**MEETING OF THE DESIGN REVIEW BOARD
MORRIS N. BROAD COMMUNITY CENTER
1175 95TH STREET
BAY HARBOR ISLANDS, FL 33154**

REVISION # 1 REVISION DATE: 07/18/23

Subject: Site Development Plan Application - Revision
Proposed New 9 DU Multifamily Residential Complex
Revisions to Approved Site Development Plan
1055 93rd Street
Bay Harbor Islands Acct. No. SPR22-000026
MMPA Acct. No. 01-0702-1144

Revision to Approved Planning and Zoning Board Submission

Sheet A-22, Exterior Elevation - WEST

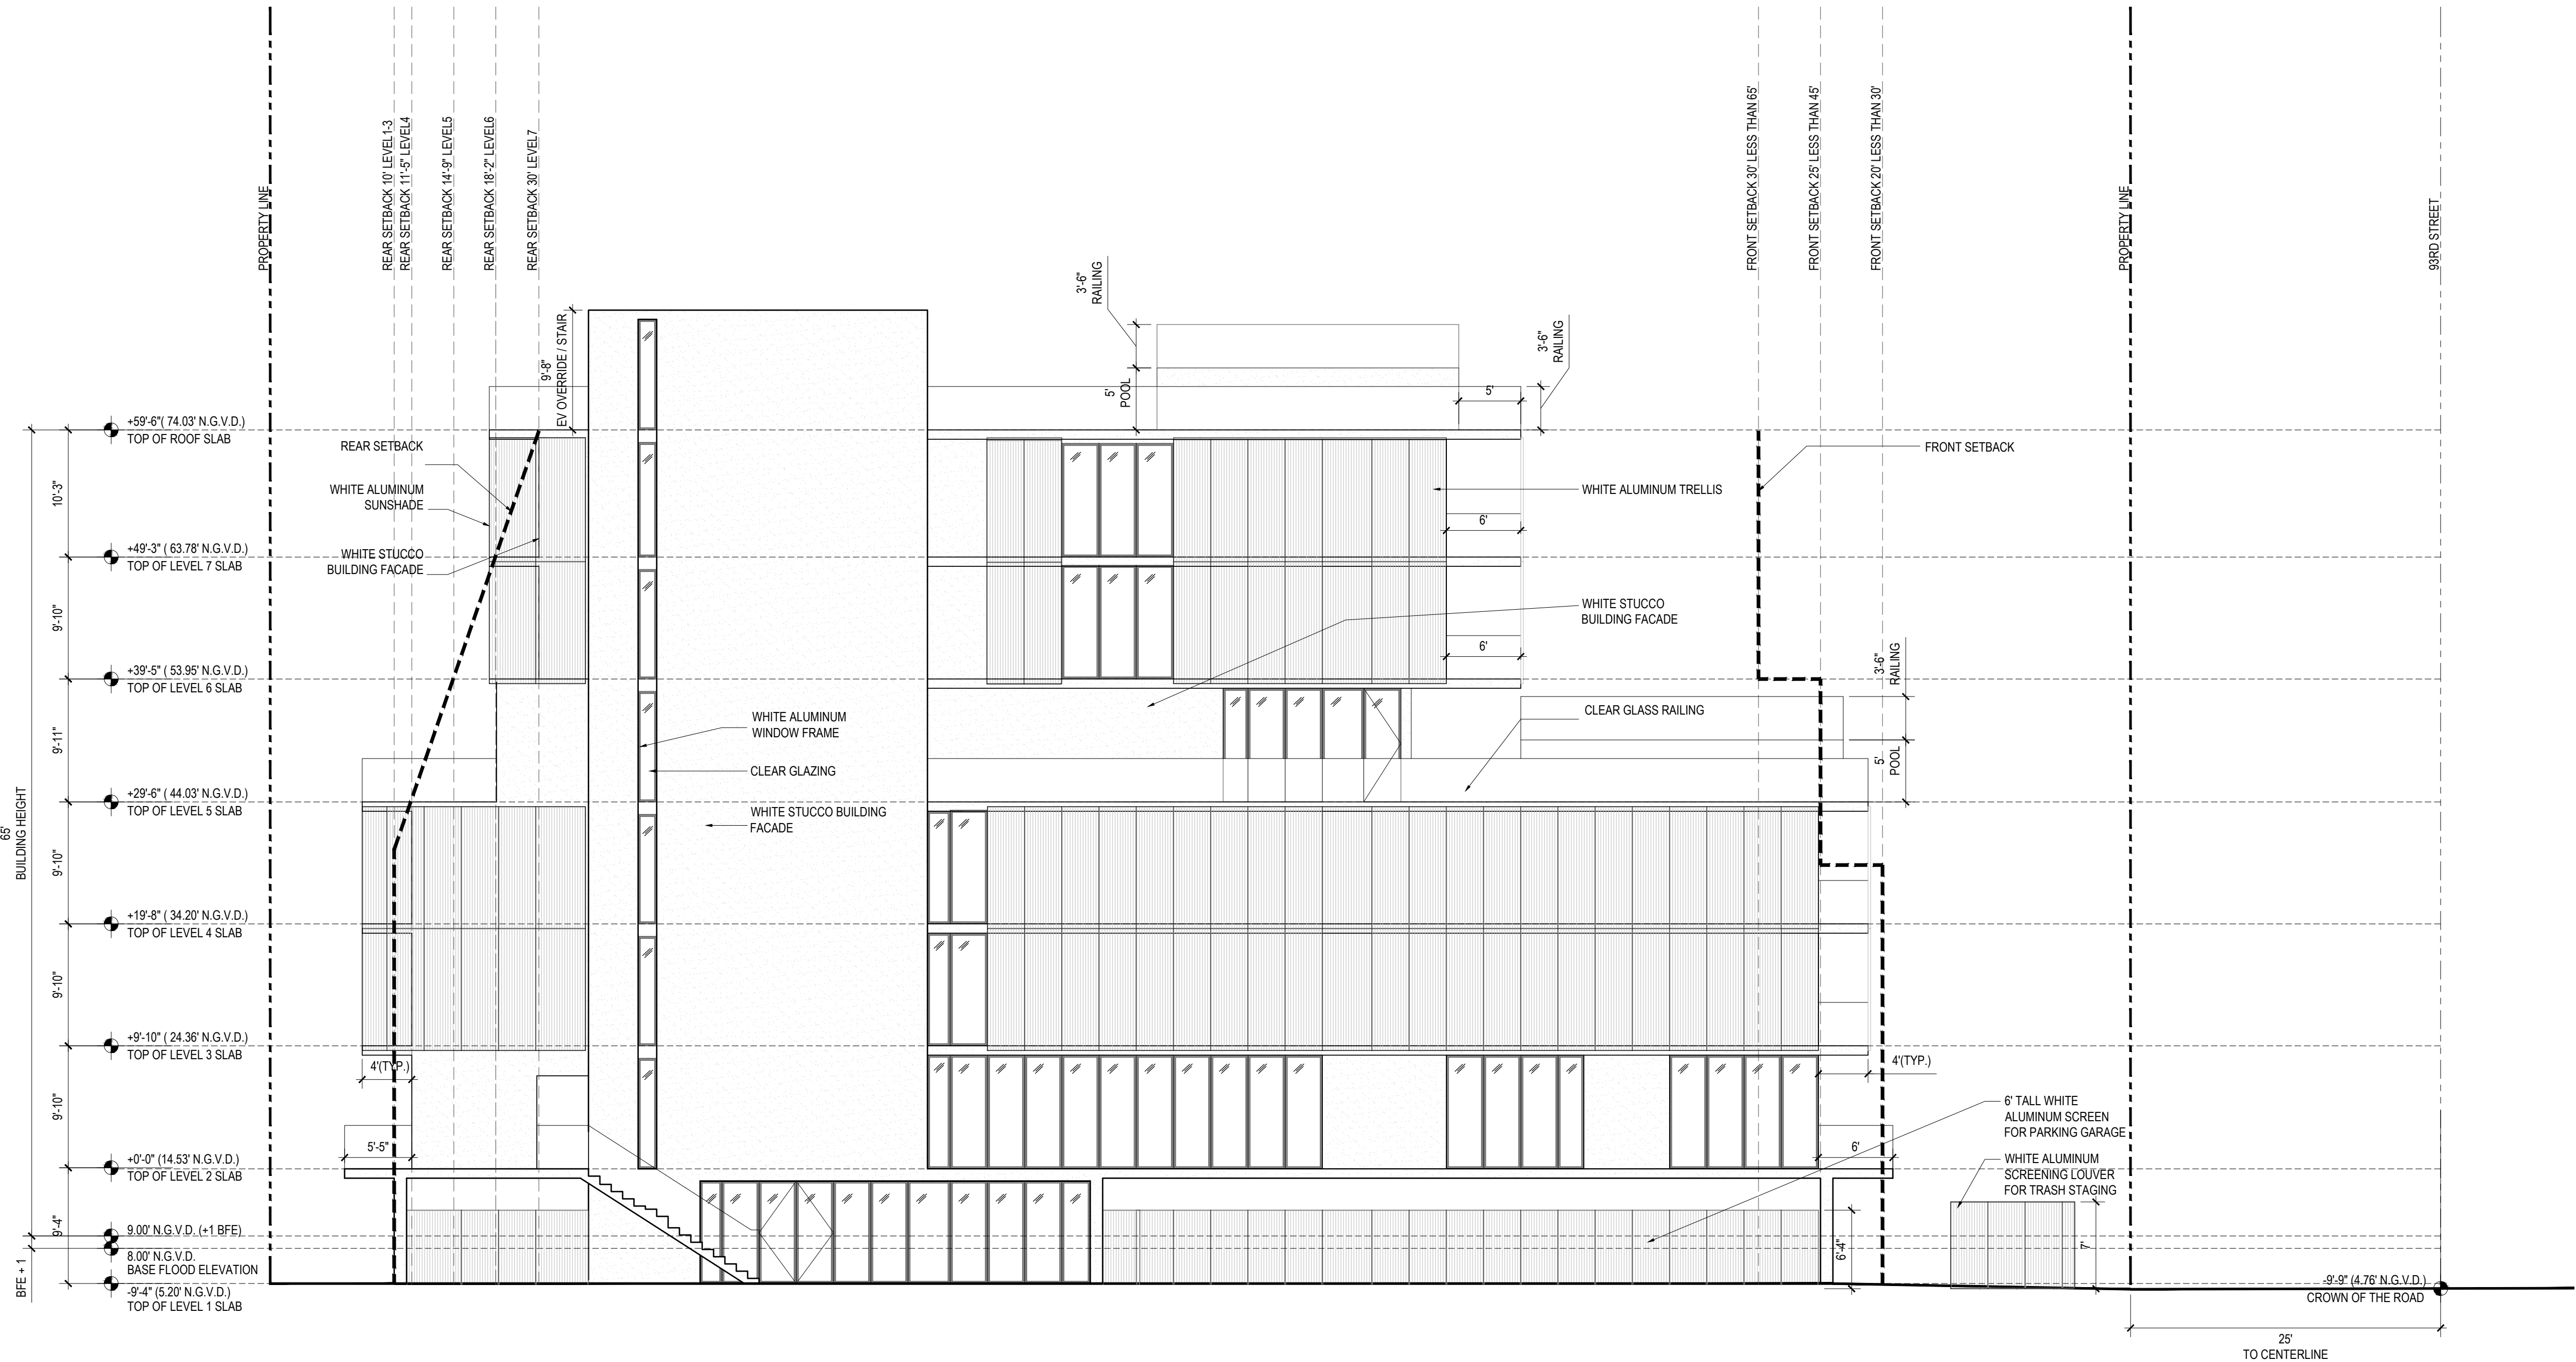
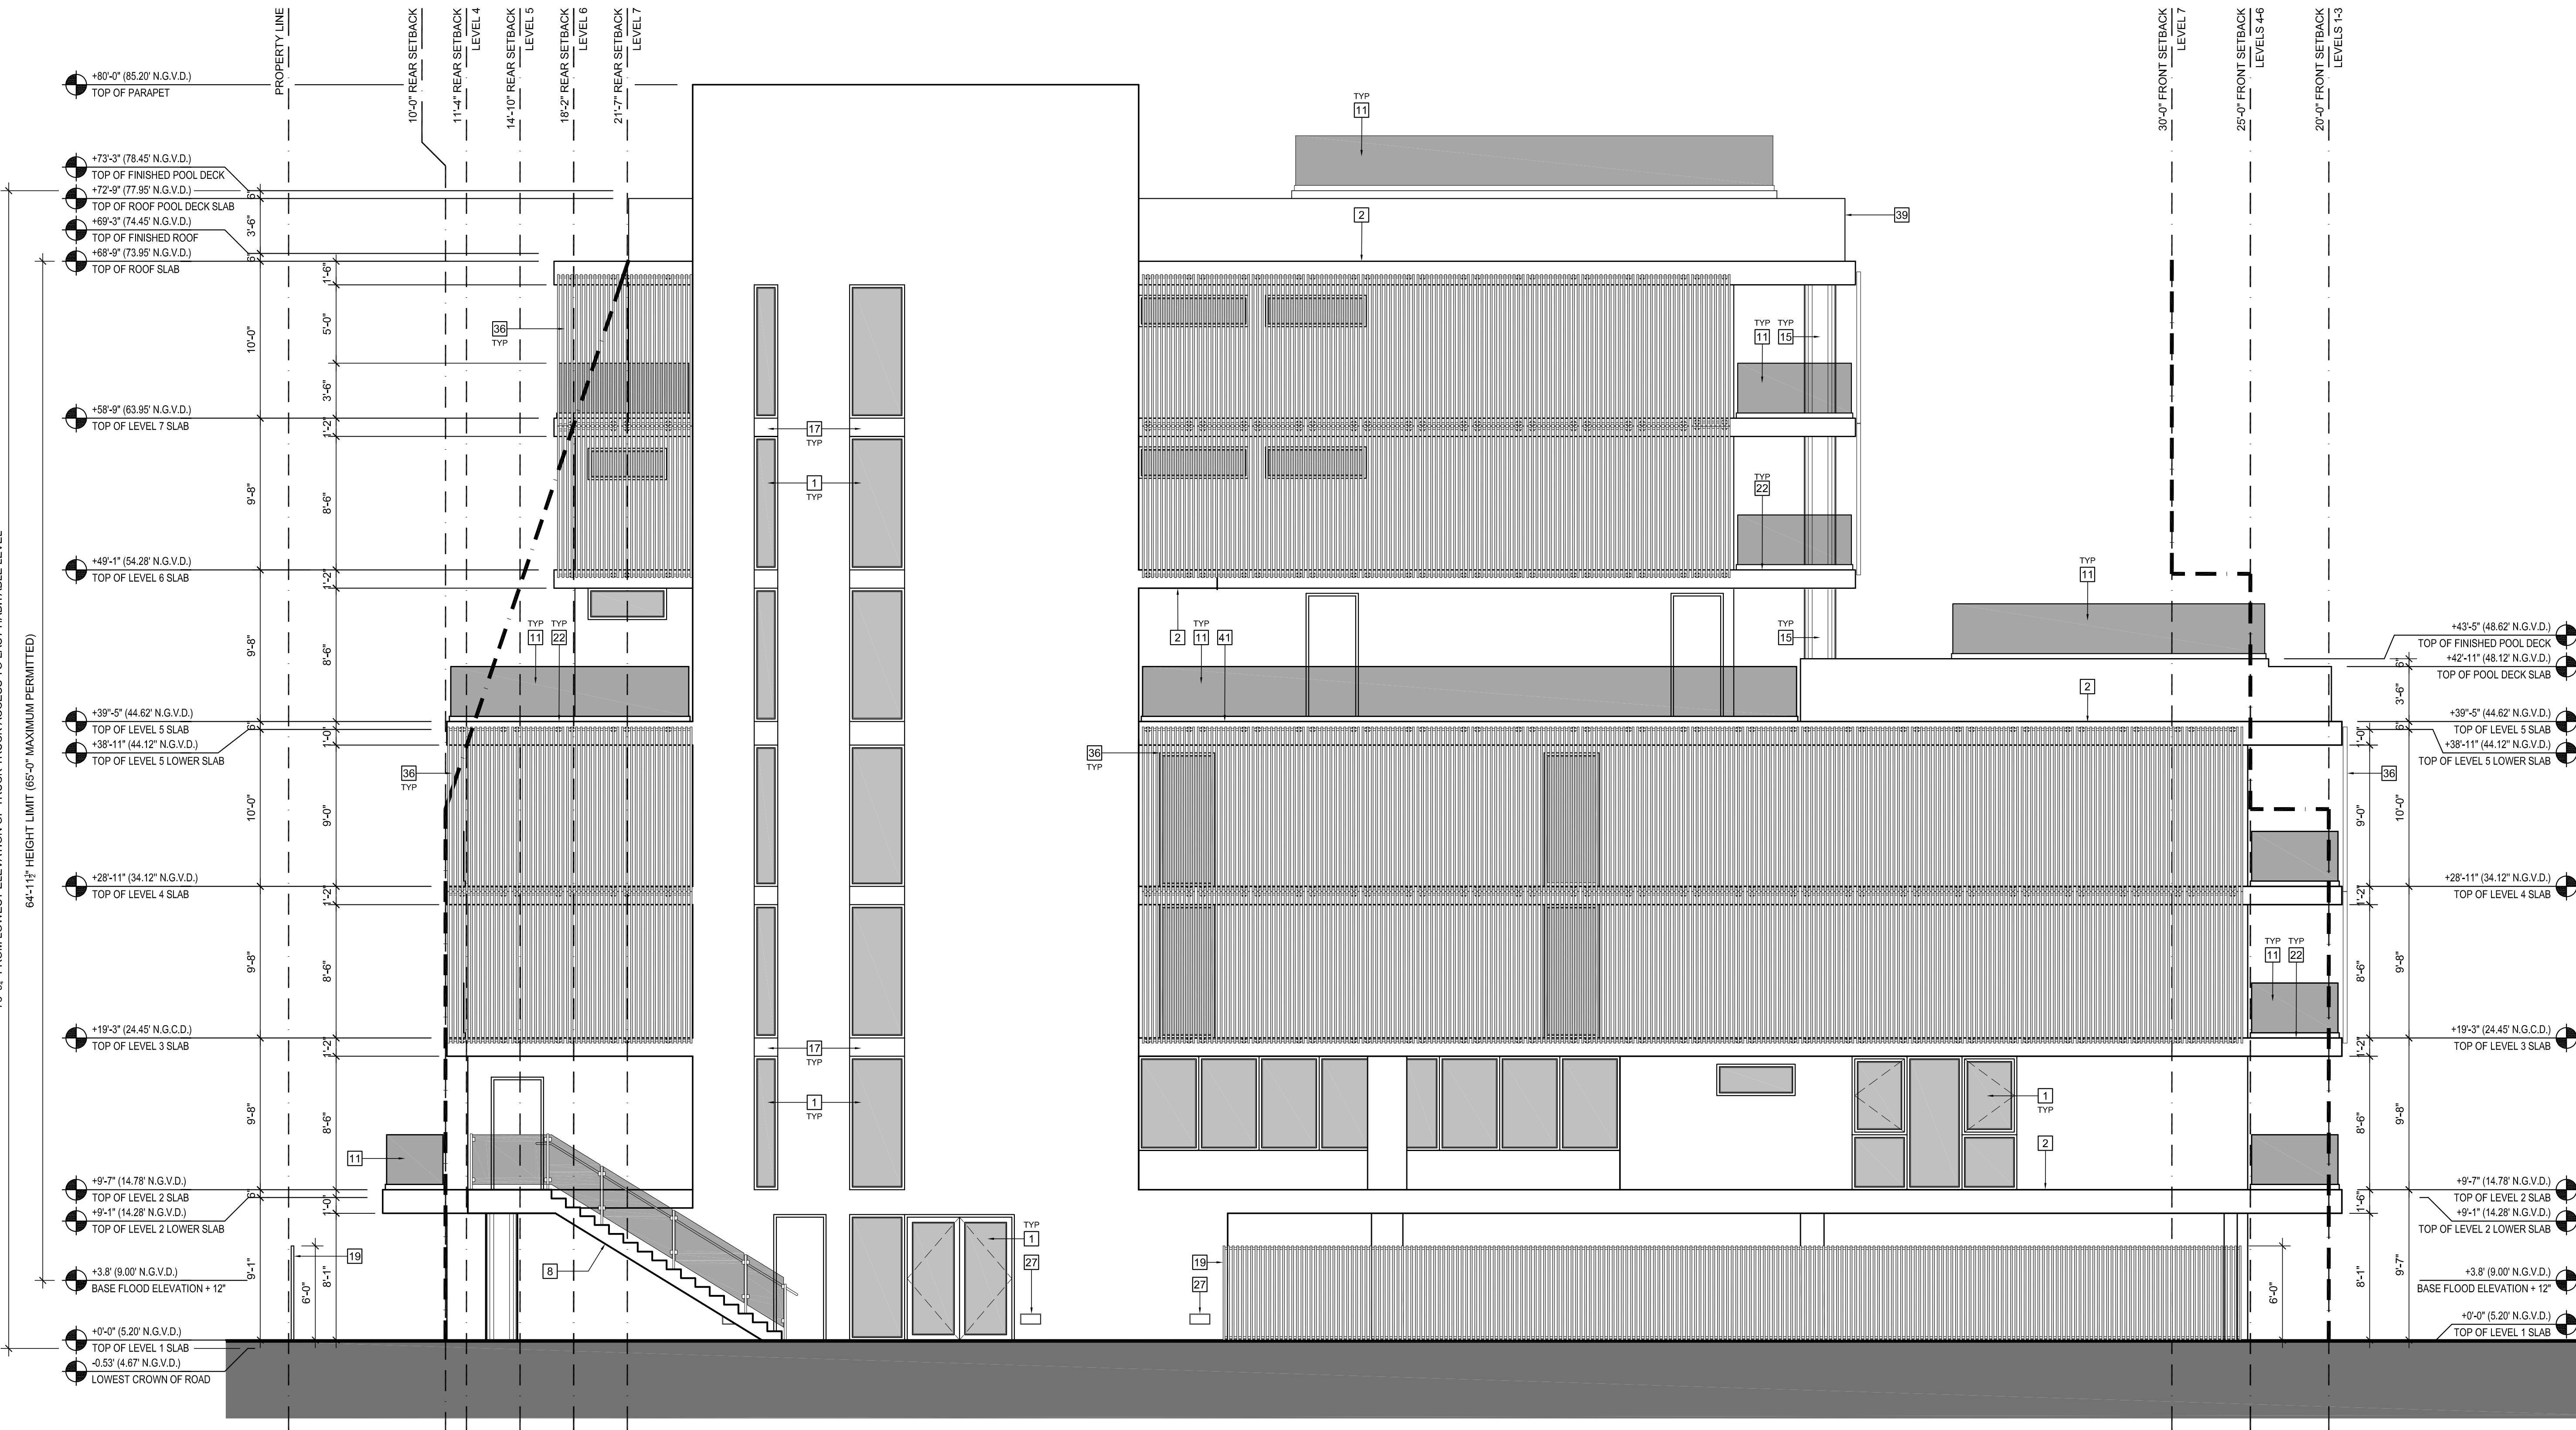
1. Modifications to the West Elevation to remove the north facing balconies and associated louvers on Levels 3 and 4 and to reduce the balcony on Level 5 due to the proximity to the FPL power lines that are running along the rear property line
2. Modifications to the exterior window/door placements and sizes due to changes to the unit layouts and coordination with Structural
